PD 1454

August 30, 2024

Re: Minor Change and Site Plan Approval for Planned Development No. 1454, related to the Proposed Joint Public Safety Training Campus at 4301 W. Chicago Ave.

Re: Minor Change and Site Plan Approval for Planned Development No. 1454, related to the Proposed Joint Public Safety Training Campus at 4301 W. Chicago Ave.

SITE PLAN COMPARISON

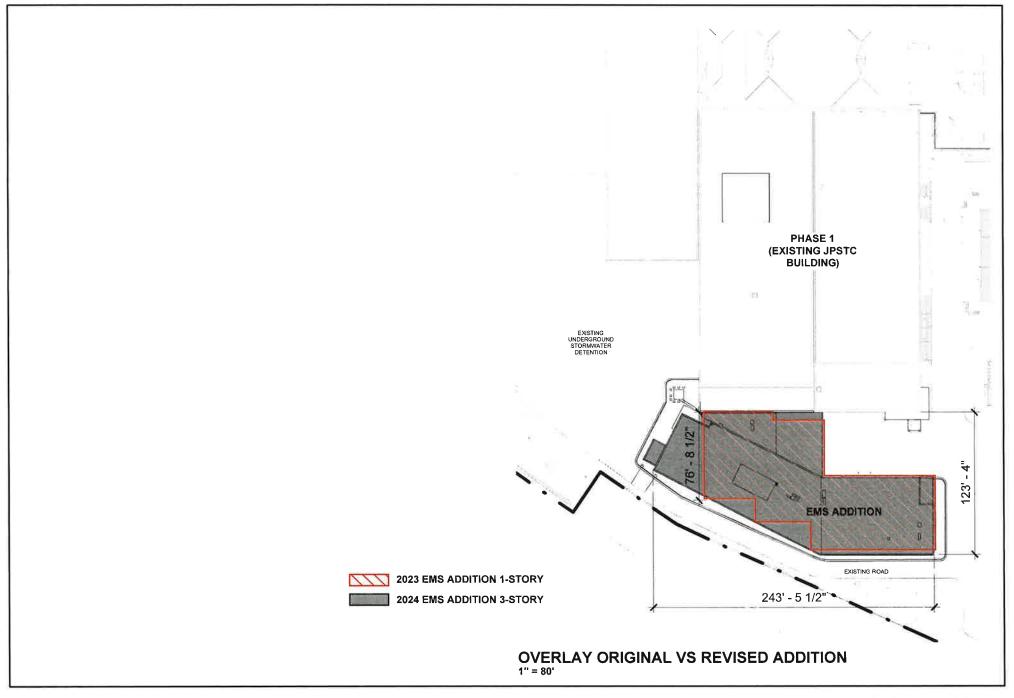
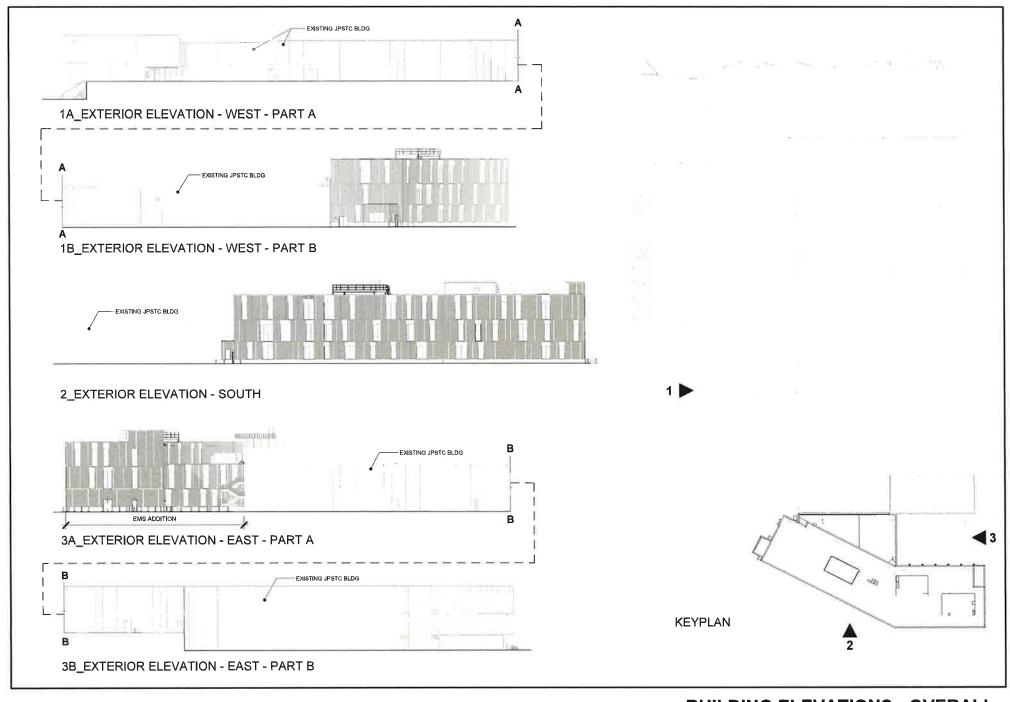
- To increase the proposed addition from 15,000sf to 52,000sf, and from 1-story to 3-stories, but the location of the addition would remain consistent at the rear of the facility as indicated in the previous approval, additionally the project would remain compliant with the allowable FAR and Height indicated in the planned development bulk table.
- To replace the previously approved OKO rain screen system with metal panels.

ENLARGED EMS ADDITION SITE PLAN

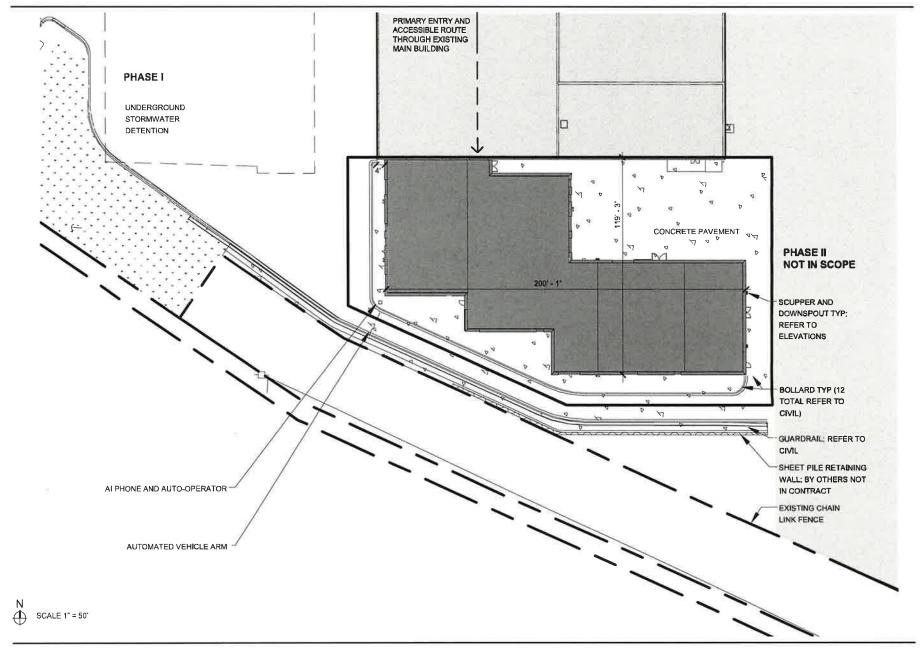
24,366 s.f. reallocation of site area from the Phase II project area to Phase I to accommodate the EMS addition. As such, Phase I will be responsible for additional pavement, site grading, and stormwater management piping in this area of the new structure.

Slight modifications to the southern part of the project site near the EMS addition. External grades needing to align with internal finished floor elevations, as a result, the

grades surrounding the EMS addition will require a slight increase in elevation. All other conditions will remain as previously approved

EMS ADDITION ELEVATIONS

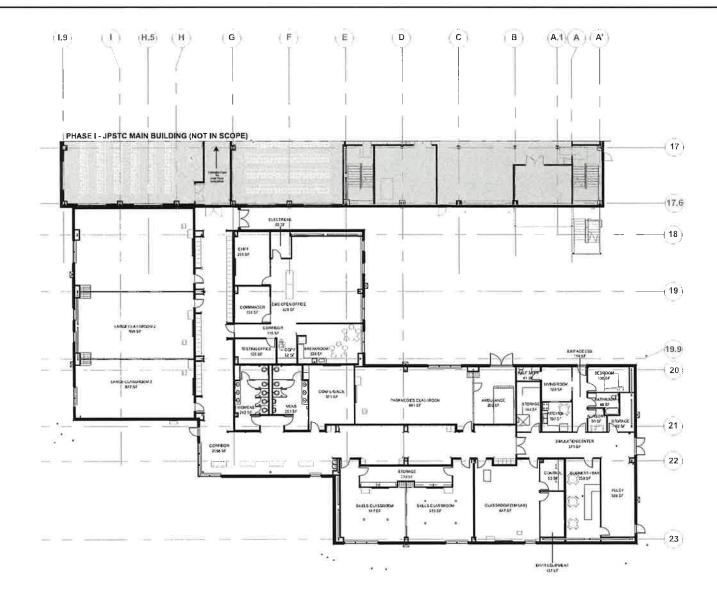
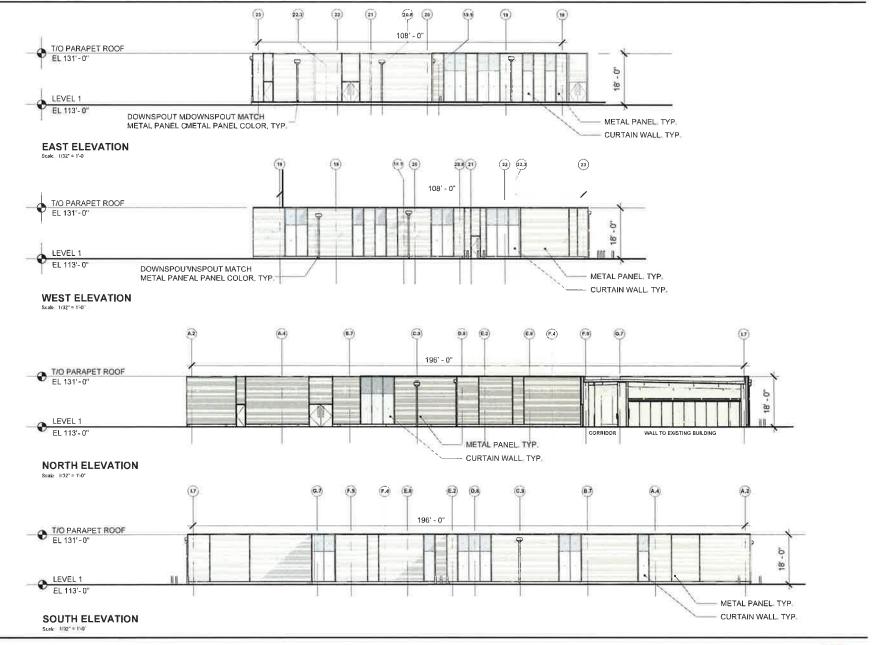
The project will add approximately 15,000sf of building area to the southern façade of the previously approved JPSTC building. The building area will not impact the overall allowed FAR for PD No. 1454, the revised proposed overall area will still be significantly less than what is allowed. The building will be a single story which is compliant with the building height limitations established by the original PD. The building façade material will be a combination of metal panel and curtainwall. There will be three metal panel profiles randomly placed within given "panel" sections which will match the random pattern of the Chicago Avenue rainscreen system. The color of the metal panel façade system has not yet been approved by the Owner (City). The curtainwall panels will also be like that of the Chicago Avenue façade as clear glazing units will be incorporated at occupant level and spandrel units incorporate above the ceiling plane.

ENLARGED PHASE 2 SITE PLAN

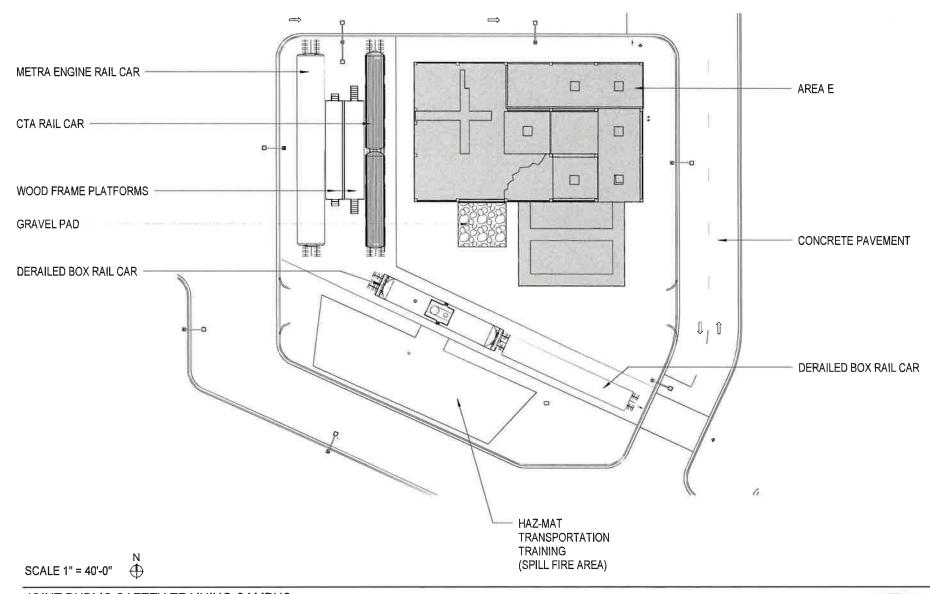
Due to the Phase 1 EMS Building addition, the road layout south of the Live Fire training structures was revised to coordinate with the revised Phase 1 access point. All other roads remain unchanged.

Grading throughout the southern half of the site was revised to minimize spoil haul-off and maintain proper elevation for connection to the Phase 1 EMS addition and existing rail line to the south.

ENLARGED URBAN TACTICAL RESCUE TRAINER FLOOR PLAN

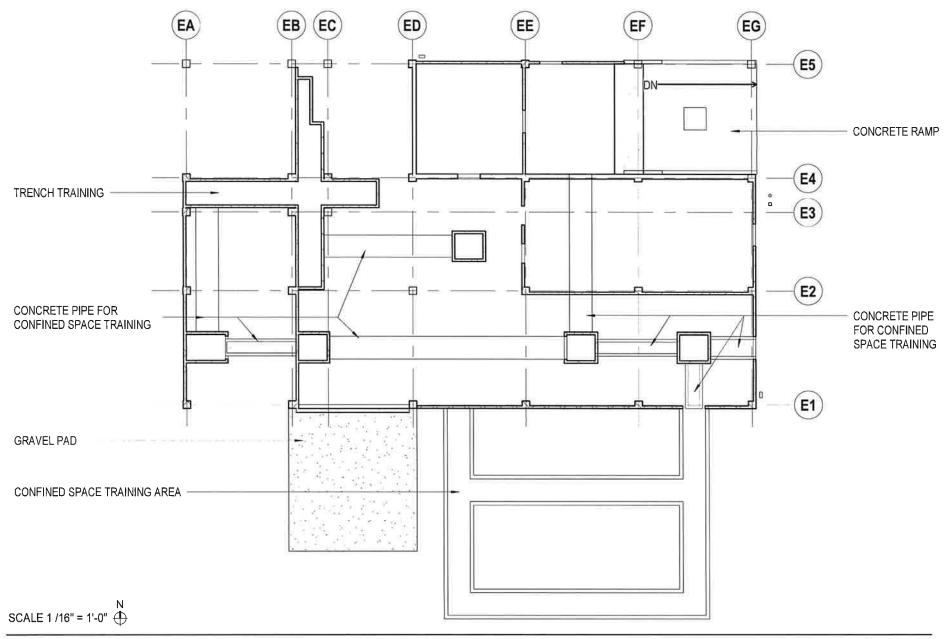
To coordinate with the revised road layout, the Urban Tactical Rescue Trainer, was reoriented (rotated and mirrored) to fit properly. Since the structure is in roughly the same location, setbacks to property lines were not largely affected and the sizing of all structure remains unchanged. The accessory components to this structure (Metra/CTA trains, training platform, and hazmat area) were also reorganized within the block to better coordinate with the revised street layout.
